Product Change Notification (PCN)

Product group:	SEMIPACK	Rev.:	0
No.:	PN25-004	Alternative supplier for baseplates of SEMIPACK 3, SEMIPACK 4 and SEMIPACK 5 pressure contact modules	21.01.2025

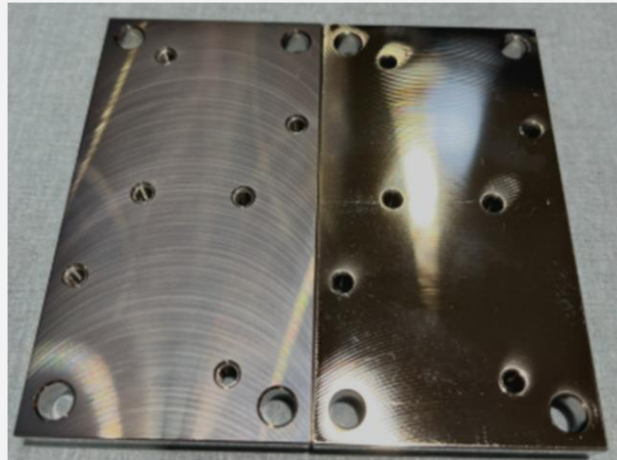
Subject of change:	Baseplate of SEMIPACK 3, SEMIPACK 4 and SEMIPACK 5
Semikron Danfoss product type:	All SEMIPACK 3, SEMIPACK 4 and SEMIPACK 5 module types
Description of change:	Introduction of an alternative supplier for the baseplates of the listed modules
Reason for change:	Securing of supply chain
Impact of change:	No change of form, fit and function of the module No change of the baseplate materials Change of optical appearance with no impact on the relevant module properties
